From: sun wo wong
Sent: Tuesday, March 26, 2024 10:55 AM
To: Ying Yeung MO/PLAND <yymo@pland.gov.hk>; tpbpd/PLAND <tpbpd@pland.gov.hk>
Subject: A/YL-PH/981

此郵件係取代本人在22-03-2024交附貴會的文件
回應各部門的擬問事宜

回應運輸署的擬問

雨水排放建議

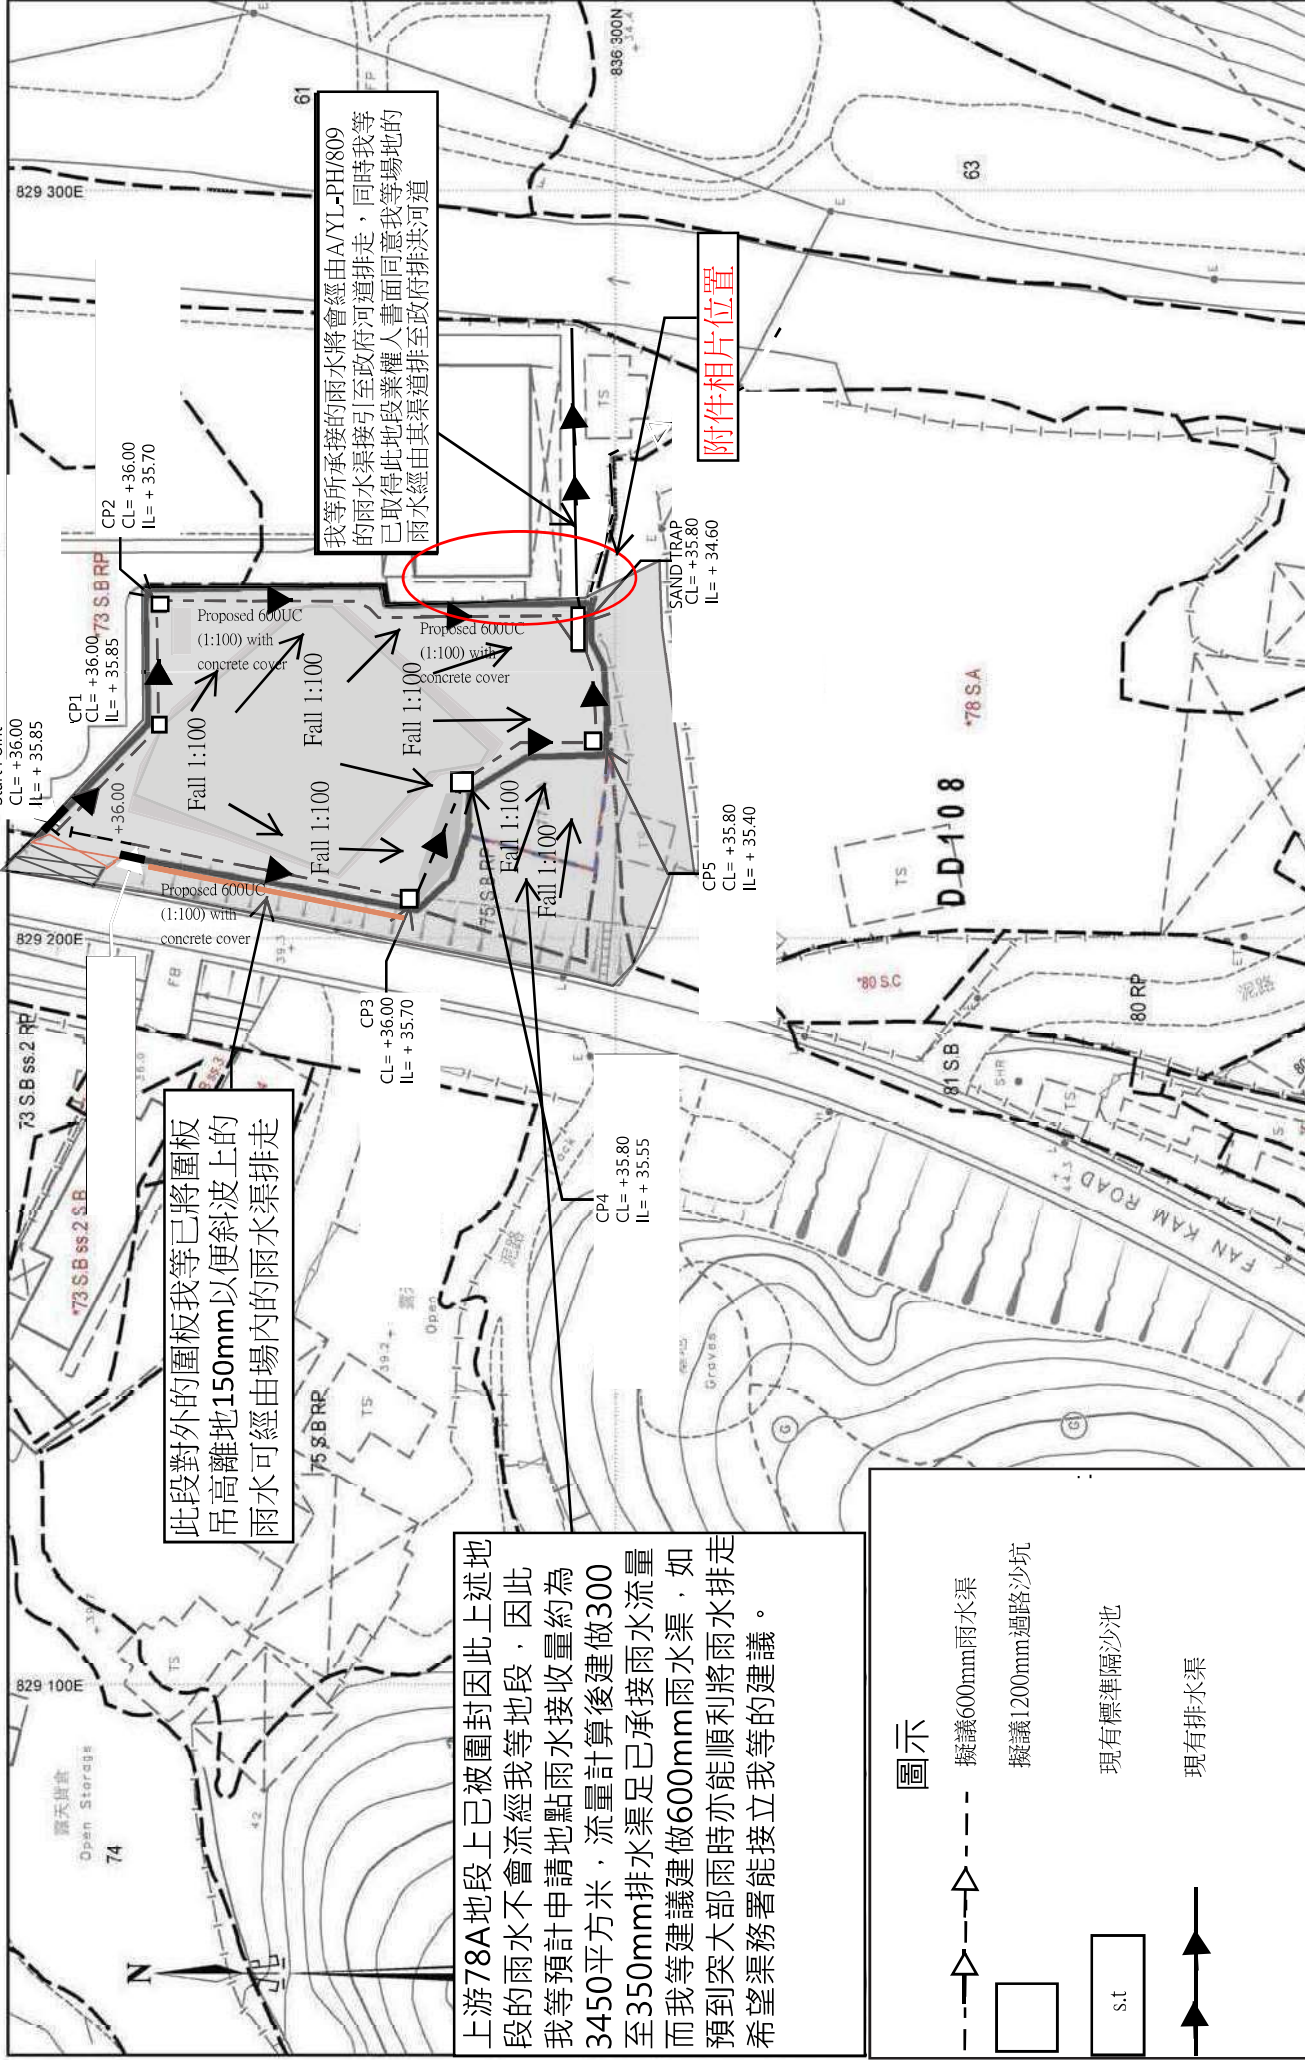
此段對外的圍板我等已將圍板吊高離地150mm以便斜坡上的雨水可經由場內的雨水渠排走

我等所承接的雨水將會經由A\YL-PH\809的雨水渠接引至政府河道排走，同時我等已取得此地役業權人書面同意我等場地的雨水經由其渠道排至政府排洪河道

上游78A地段上已被圍封因此上述地段的雨水不會流經我等地段，因此我等預計申請地點雨水接收量約為3450平方米，流量計算後建做300至350mm排水渠足已承接雨水流量而我等建議建做600mm雨水渠，如預到突大部雨時亦能順利將雨水排走希望渠務署能接立我等的建議。

Catchment Area of site = 3450 m²
 Site Catchment Area = 0.003450 km²
 Peak runoff in m³/s = 0.2778 x 0.95 x 250mm/hr x 0.003450 km²
 = 0.22778 m³/s
 = 1.3667 liter/min

1. Catchpit (CP1-CP5) with desilting facility shall follow CEDD's standard drawing No. C2406I.
2. Catchpit and UC follows Typical Details of Geotechnical Manual for Slope Fig.8.10 and Fig.8.11 respectively.
3. The inverted level of the connection point shall be verified on site prior the commencement of work
4. Grating Concrete Cover follows CEDD's standard drawing No. C2412E: U-CHANNELS
